Subject: NH-0013(637)  
Tuscaloosa County  
December 8, 2023 Letting

RE: Project No. NH-0013(637)  
Resurfacing on SR-13 (US-43) from 0.27 Mile South of Northside Road to Fayette  
County Line  
Micro-Milling, Resurfacing, Scoring, and Guardrail  
Tuscaloosa County  
Flagged Revision #1

Attached are full size (PDF) of flagged revised sheets on the above-mentioned project for the revision of a tie-in detail title discovered during the investigation of a contractor's question.

TIE-IN DETAIL AT BRIDGES/ BRIDGE CULVERTS

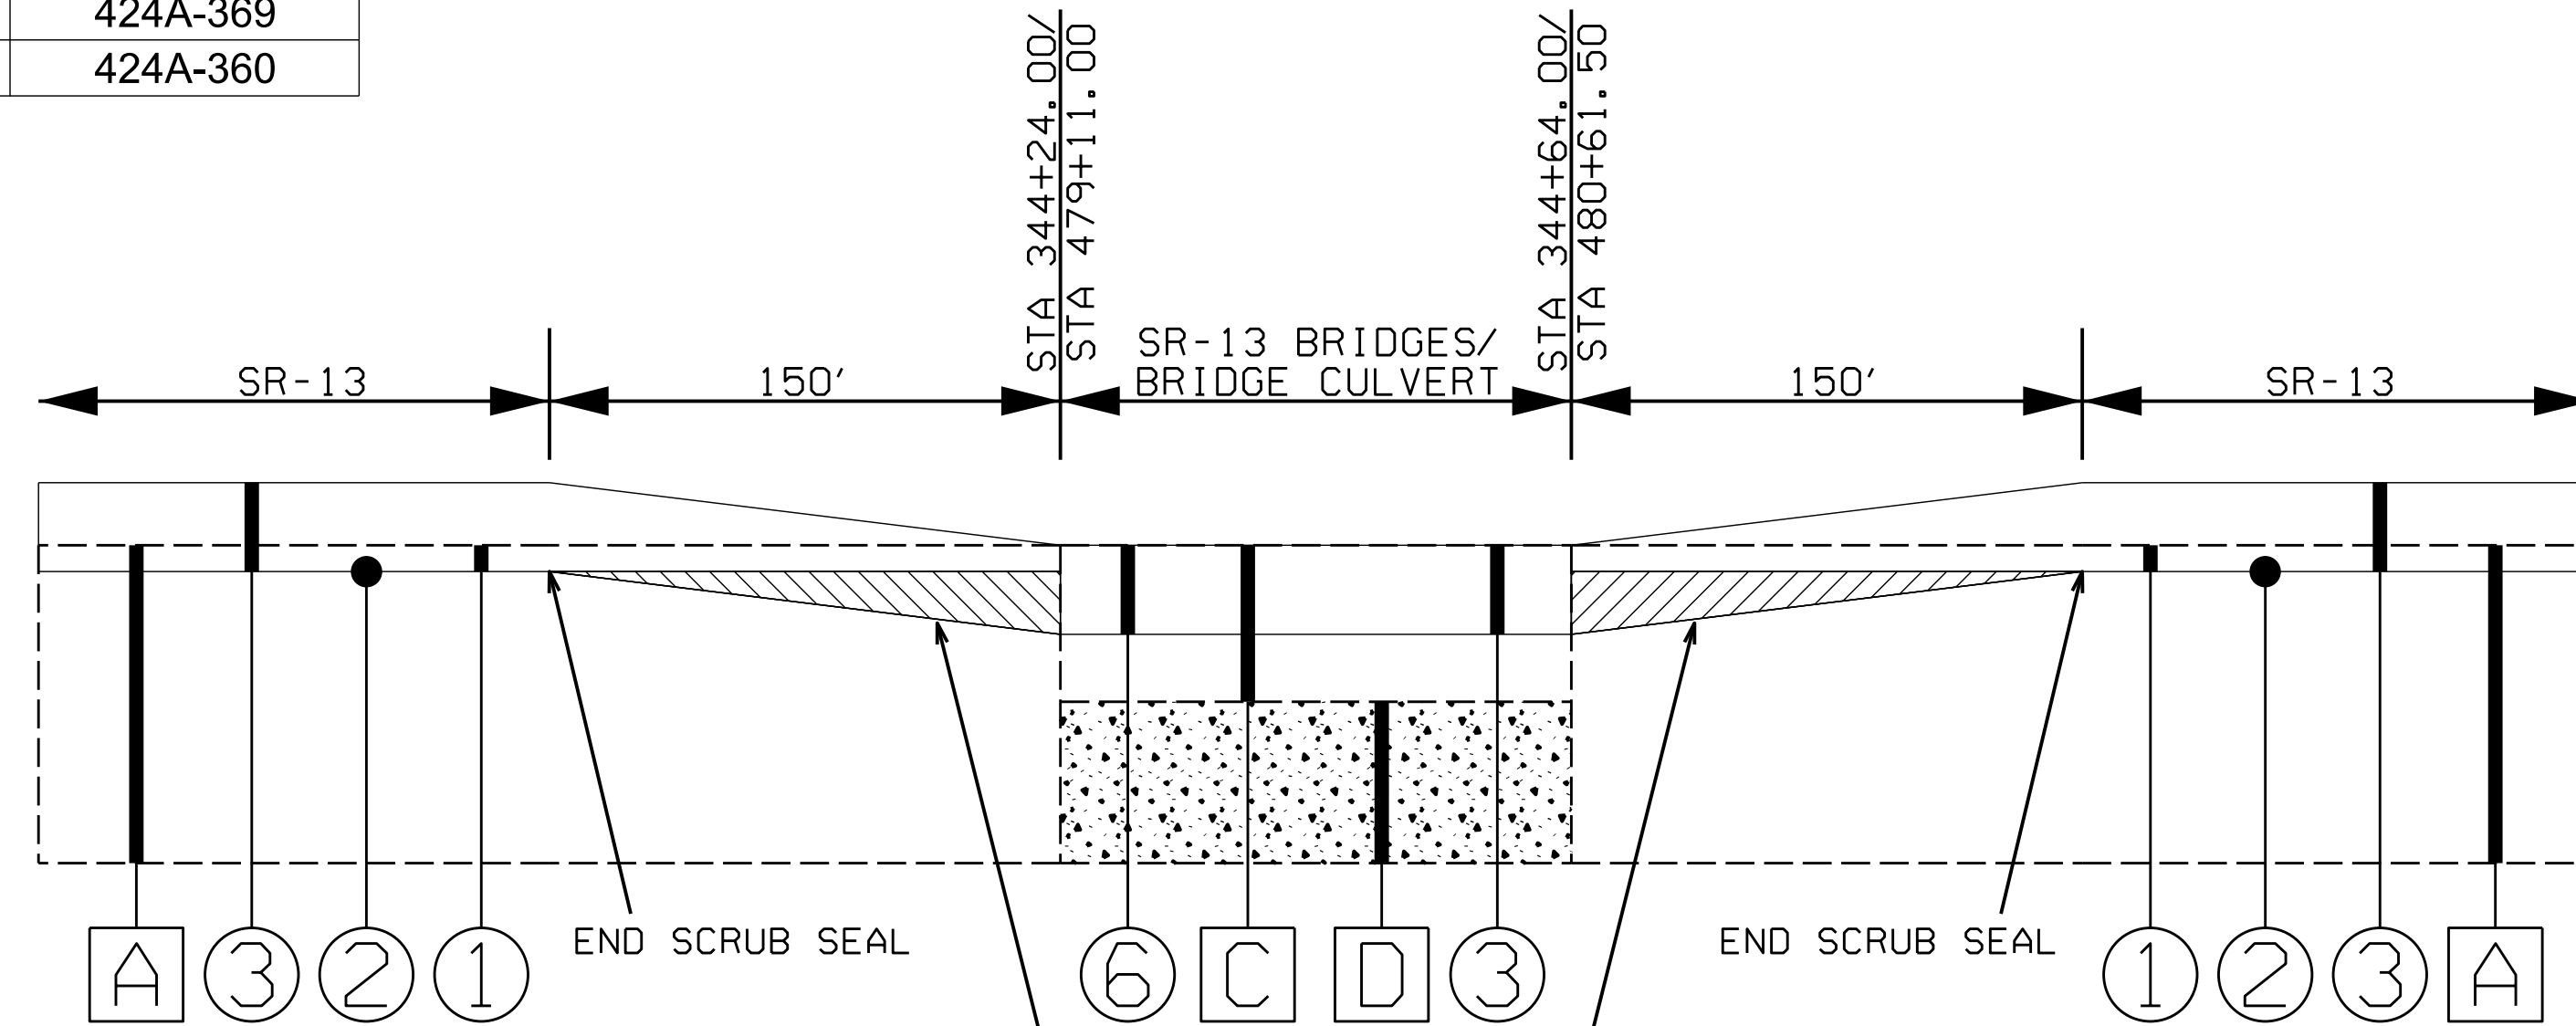
- Changed title of bottom right detail from "Tie-In Detail at Begin/End Project" to "Tie-In Detail at Bridges/ Bridge Culverts."

1 - REVISED SHEET TITLE FROM "TIE-IN DETAIL AT BEGIN/ END PROJECT" TO "TIE-IN DETAIL AT BRIDGES/ BRIDGE CULVERTS" ON 12-1-23. JML
